February 17, 1984

Docket No. 50-320

Subject: NRC Staff Safety Evaluation of First Pass Stud Detensioning

FIGURE 1

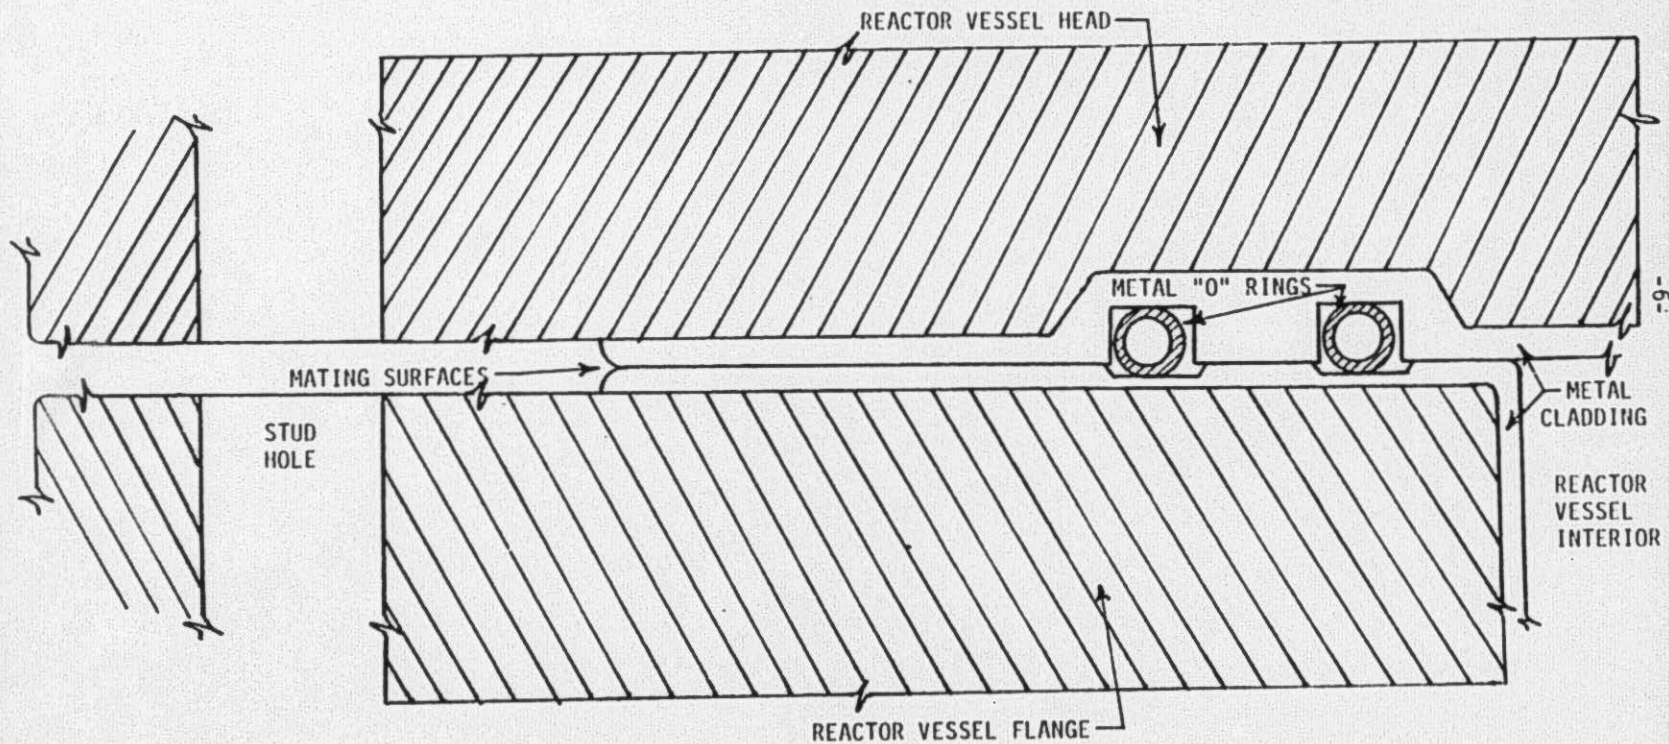
As part of our evaluation of the pressure retaining capability of the RPV, we examined the impact that first pass stud detensioning might have on the two metal "O" ring gaskets in the RPV flange. Because of the geometrical configuration of the vessel and head mating surfaces and the location of the studs in the perimeter of the flange (see Figure 1), the fully tensioned condition produces a slight deflection or gap between the mating surfaces at the RPV radial location inside the "O" ring gaskets. When the studs are detensioned, this gap is reduced. Thus, first pass stud detensioning actually increases the compression of the mating surfaces on the flange "O" ring seals, thereby maintaining the full integrity of the flange seals. We also note that the "O" rings are designed as hollow tubes with slotted holes which permit the "O" ring to expand (when subjected to rising vessel pressure) against the flange mating surfaces and ensure a good seal. We have also examined the estimates you provided for the maximum temperatures that the "O" ring gaskets were subjected to during the accident sequence to determine if the silver cladding (0.004 to 0.006 inches thick) on the stainless steel gaskets might have degraded and affected sealing capability. We concur with your analysis which concludes that the temperatures in the vicinity of the "O" rings would be bounded by the estimated maximum temperature (approximately 485 °C) of the inside surface of the vessel in the flange region during the accident sequence. The "O" rings are protected to a degree by virtue of their location in the RPV flange which consists of a massive amount of metal capable of acting as a heat sink during a transient. We conclude that the temperatures occurring in the flange during the accident sequence would not have affected the integrity of the silver cladding (the melting point of silver is approximately 960 °C) on the "O" ring seal. Accordingly, the "O" ring should be capable of performing its intended function with little risk of leakage through the flange seal in the event the vessel is refilled and pressurized at some time in the future.
